INSTRUCTIONS FOR INSPECTING, ADJUSTING AND/OR REPLACEMENT
OF PARTS FOR OBTAINING LIMIT SWITCH ADJUSTMENTS
ON BROWN BOVERI 7.5KV THRU 15KV, 500 THRU 750 MVA;
5HK350, 3000; ALL HKV BREAKERS

IB-8303

INSTRUCTIONS FOR INSPECTING, ADJUSTING AND/OR REPLACEMENT
OF PARTS FOR OBTAINING LIMIT SWITCH ADJUSTMENTS
ON BROWN BOVERI 7.5KV THRU 15KV, 500 THRU 750 MVA;
5HK350, 3000; ALL HKV BREAKERS
 (MANUFACTURED BETWEEN MARCH 1974 AND JULY 1978 INCLUSIVE)

Fig. 1

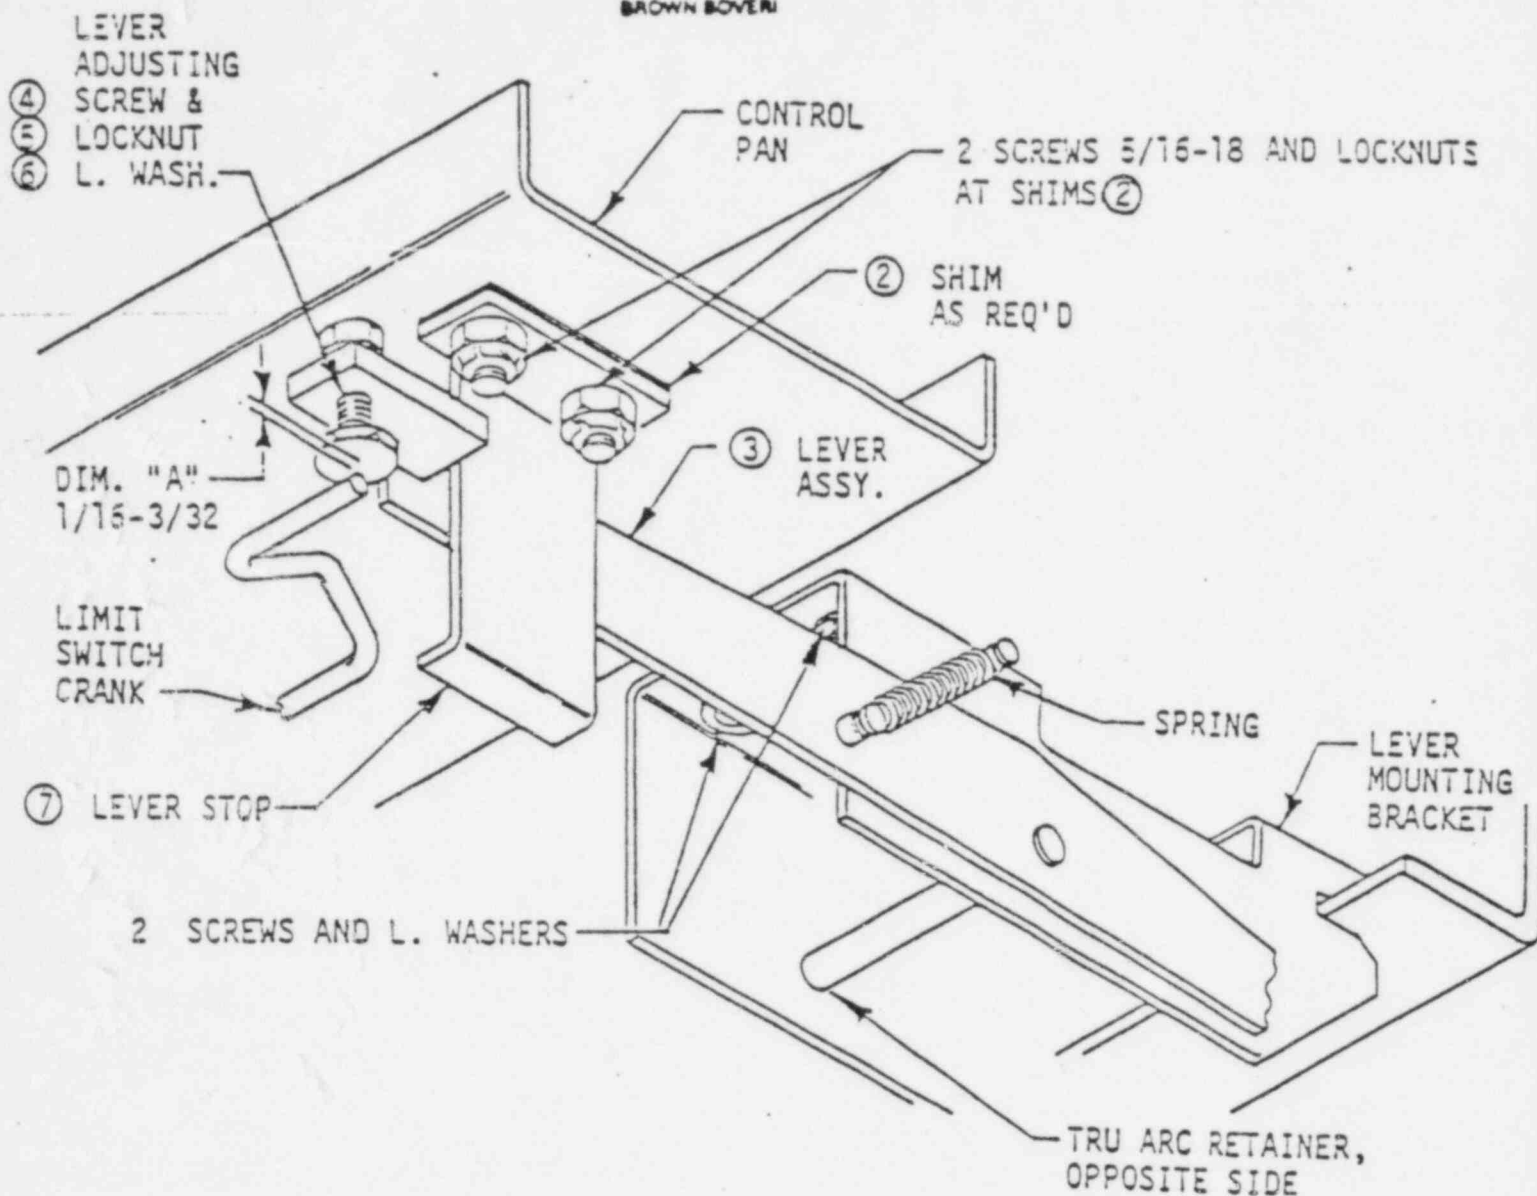
2. INSPECTION AND ADJUSTMENT FOR DIM. "A" (See Fig. 1)

- 2.1 Charge the closing springs electrically or manually.
- 2.2 Check Dim. "A" with feeler or pin gages.
- 2.3 If required, readjust the screw (4) to Dim. "A" after first loosening the jam nut (5) and then retightening the jam nut after the adjustment.
- 2.4 Close and open the breaker to discharge the closing springs.

Fig. 2

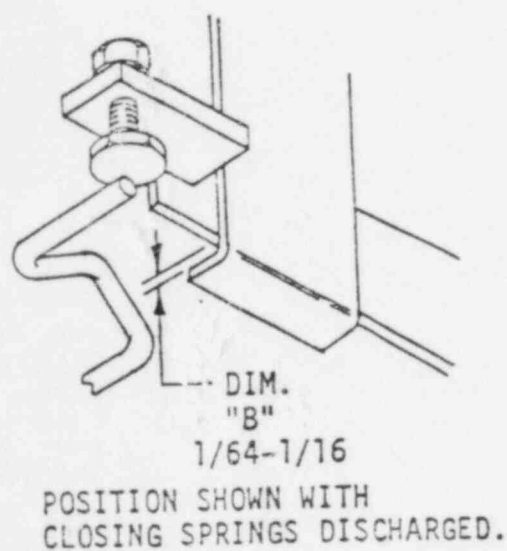
3. INSPECTION AND ADJUSTMENT FOR DIM. "B" (See Fig's 1 and 2)

- 3.1 For this procedure, the breaker is to be open and the closing springs discharged.
- 3.2 Check Dim. "B" with feeler or pin gages. (See Fig. 2)
- 3.3 If Dim. "B" is not within dimensions, it is necessary to shim the lever stop(7) up or down as required. This is done by adding or removing shims(2) at the lever stop. (See Fig. 1) Note that if all shims are removed and the Dim."B" still exceeds the max. allowed, the length of the lever stop should be checked. The lever stops made after July 1978 are $2 \frac{17}{32}$ long. Previous to this, the length was $2 \frac{25}{32}$. If required, install the shorter lever stop (7).

<u>Qty. Per Breaker</u>	<u>Notes</u>
2. Shim 650451-A27	As req'd (3 est.)	
7. Lever stop 193392-A	1	2 17/32 overall length. Used in breakers built after July 1978.
